T.I. no.: 2017 - 05 Updated: -	Topic: AHA lubrication plan
---	------------------------------------

CORRECT LUBRICATION OF AHA

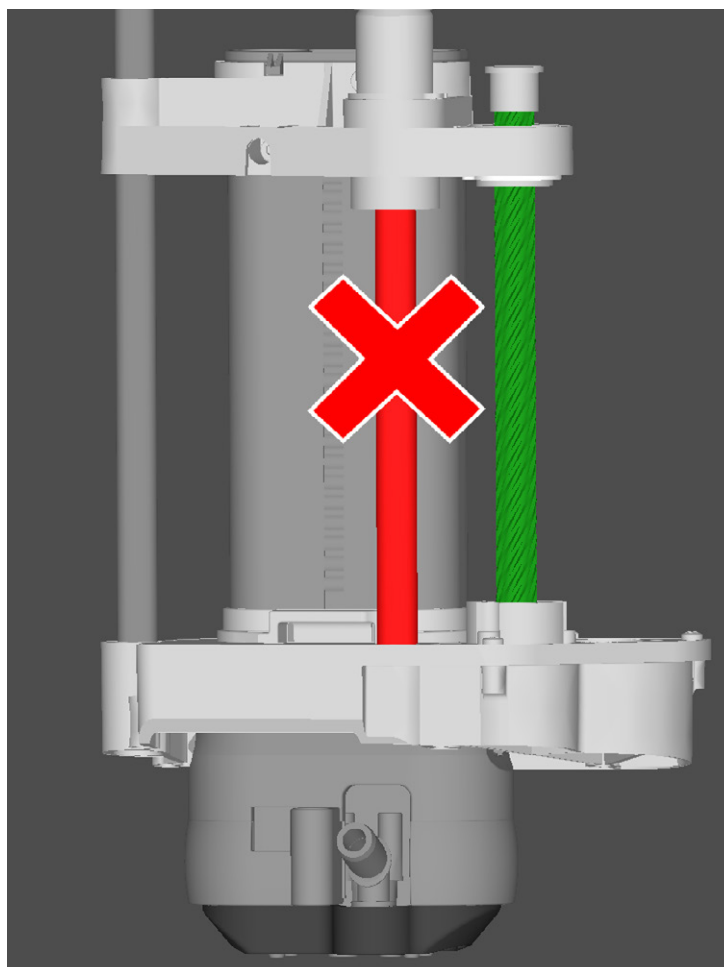
The guide (red) is self-lubricating. Adding extra lubrication gums up the guide, causing it to jam. Never add extra lubrication to the guide.

During service work, however, the guide (red) should be cleaned of contamination (e.g. deposited milk foam, ground coffee dust) with a dry towel.

In the AHA of the SCA P BF, only the spindle (green) and the spindle gear should be lubricated. Use Polylub GLY801 (part no. 065303) for lubrication.
